Model: GW-C1		Date: 21-Apr-06	No.: RB283001b
Subject: ROM History (BICU)		Prepared by: H. Saitoh	
From: 1st Tech. Support Sec. Service Support Dept.			
Classification:	<input type="checkbox"/> Troubleshooting <input type="checkbox"/> Mechanical <input type="checkbox"/> Paper path <input type="checkbox"/> Product Safety	<input type="checkbox"/> Part information <input type="checkbox"/> Electrical <input type="checkbox"/> Transmit/receive <input type="checkbox"/> Other (     )	<input type="checkbox"/> Action required <input type="checkbox"/> Service manual revision <input checked="" type="checkbox"/> Retrofit information

Model: Model K-C3/GW-C1		Date: 15-May-07	No.: RB245023
Subject: Countermeasure for duplex printing error		Prepared by: Y.Murata	
From: 1st Tech. Support Sec. Service Support Dept.			
Classification:	<input type="checkbox"/> Troubleshooting <input type="checkbox"/> Mechanical <input type="checkbox"/> Paper path <input type="checkbox"/> Product Safety	<input type="checkbox"/> Part information <input type="checkbox"/> Electrical <input type="checkbox"/> Transmit/receive <input checked="" type="checkbox"/> Other (      )	<input type="checkbox"/> Action required <input t

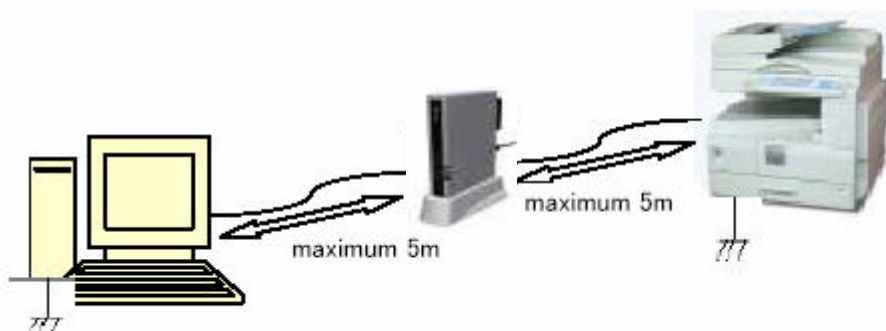
1. Use the USB cables included with the Greatwall-C2, or USB cables that comply with the USB2.0 (shielded cable) standards.

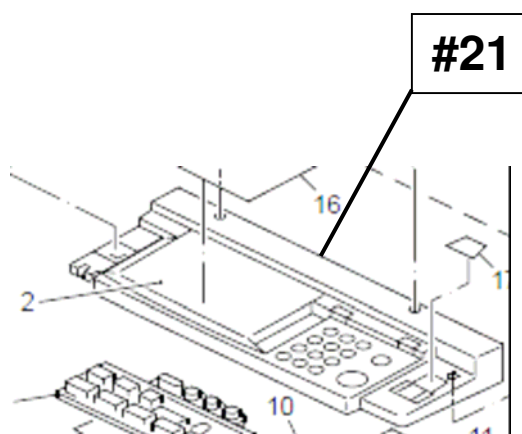
**Change:** An index in the illustration was added.

**Reason:** Correction of illustration and part number.

**See the following diagram for the corrected illustration.**

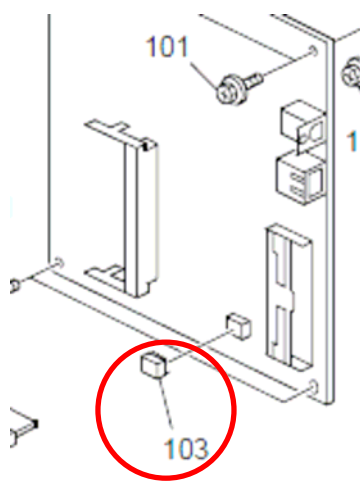
**Change:** Part number **14076612** and the illustrations were deleted.

**Reason:** EEP-ROM as a new spare part cannot be used on the GDI controller board as a single replacement component because it causes network connection failure. Please replace the controller board if you need to replace the RAM.

**Part encircled in red in the following diagram is deleted.**
